**3 Volt Intel[®] Advanced Boot
Block Flash Memory
28F004/400/008/800/
016/160/320/640B3 (x8/x16)**

Specification Update

April 2002

Order Number: 297948-012

2. Invalid Read Durations for CE# High Pulse Width

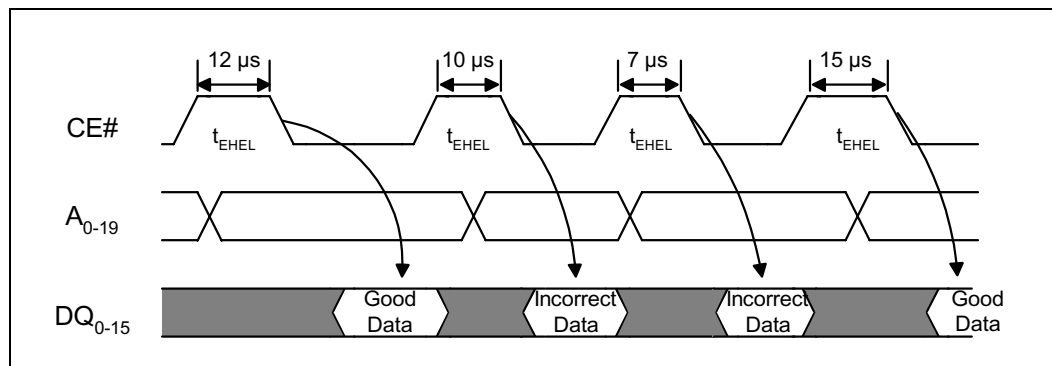
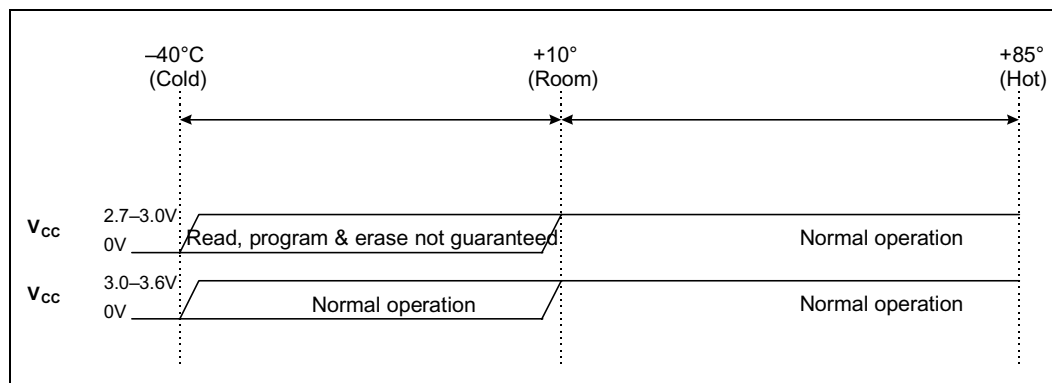
Problem: During consecutive read operations, CE# may be left low or toggled as desired. If CE# is toggled high (see diagram below) for 4 μs –11 μs between read operations, subsequent reads will return incorrect data.

Implication: If CE# is not toggled between consecutive reads, there is no impact. Any application that toggles CE# between read operations will be affected if the CE# high pulse width is within the nonfunctional range, i.e., 4 μs \leq t_{EHEL} \leq 11 μs .

1. Do not toggle CE# between consecutive read operations
2. Insure t_{EHEL} is less than 4 μs or greater than 11 μs

7. 28F320B3xC Reset Failure

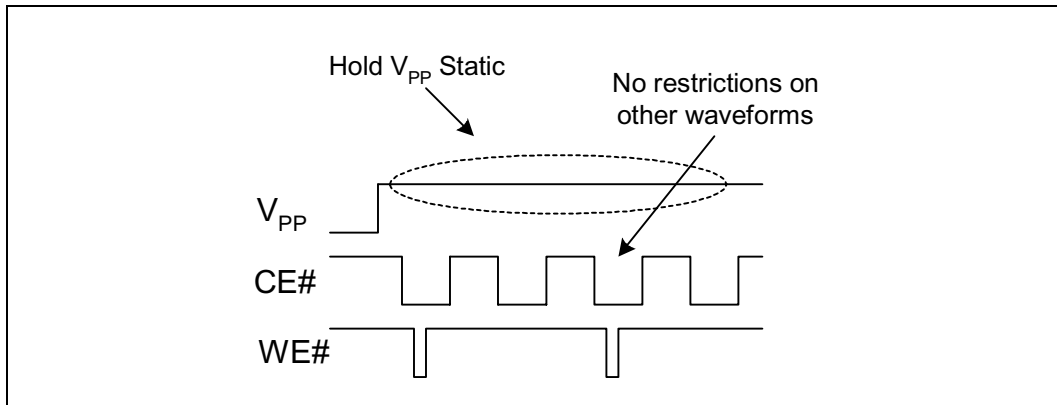
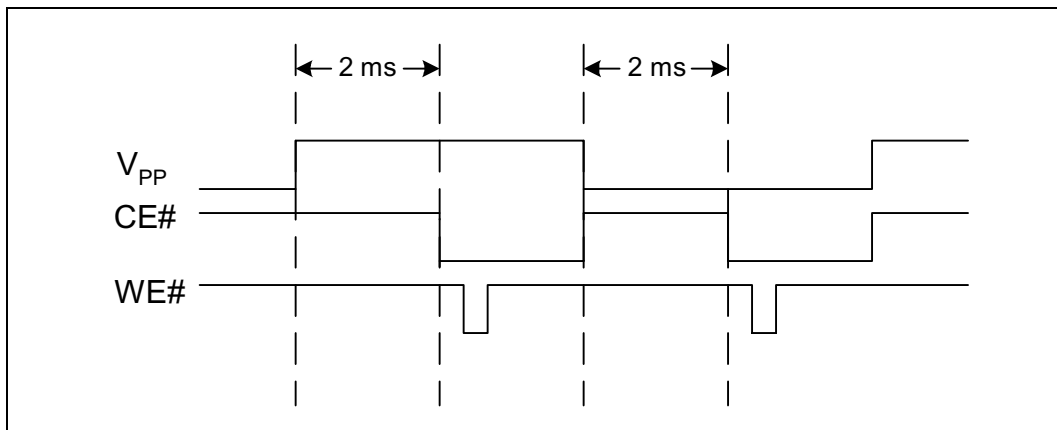
Problem: The 0.18μm 28F320B3xC devices can unintentionally reset under certain conditions where V_{PP} toggles.

Implication: When the reset occurs, any command being executed is interrupted and the flash switches to read array mode.

- 1) Tie V_{PP} to V_{CC}
- 2) If the third and fourth digits on the top side FPO mark (third line) are equal or greater than “23”, then V_{CC} may be set from 2.7 V to 3.3 V. V_{CC} must not exceed 3.3 V.
- 3) Set V_{PP} to a static high or static low level as shown here; and

- 4) Wait 2 ms after a V_{PP} transition to access the flash device as shown here.

Figure 1. Workaround Placement

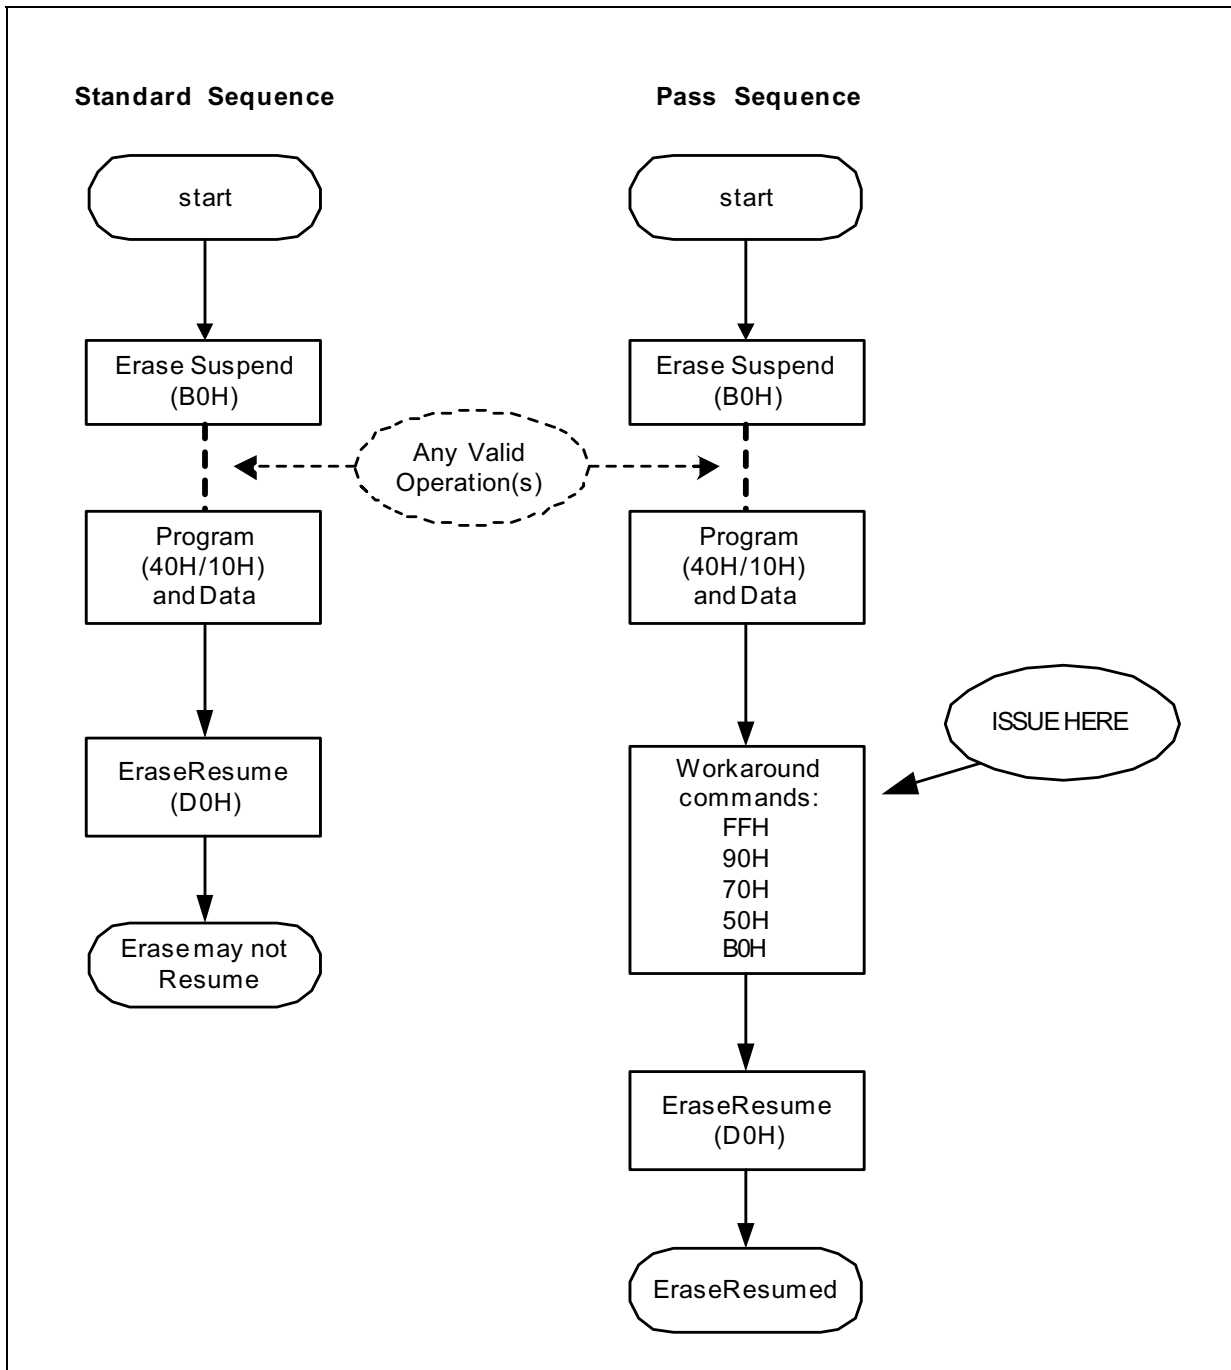
Problem: On the 0.18µm 28F160B3xC device, a design anomaly was discovered. During an Erase-Suspend operation, if the Program (40H/10H) sequence is executed, under limited conditions the proceeding Erase Resume command (D0H) may not actually resume the device. No customers have reported failures in product applications. Customers who use any version of FDI (Intel Flash Data Integrator) software will not see this issue. If the Read Array command is issued prior to the Erase Resume command, users will not see the issue (typical in XIP applications).

Implication: The Resume Command (D0H) may be ignored by the device and will not correctly resume. The device will appear to remain in suspend (via status register). After a reset of the flash device the status register will clear. This failure has been recreated in a lab environment only.

1. If FDI (Intel Flash Data Integrator) software is used, users will not see the issue.
2. During an Erase-Suspend (B0H), user must issue any of the following commands listed in Table-1 after issuing the Program (40H/10H) and data sequence but before issuing the Erase-Resume (D0H) command.
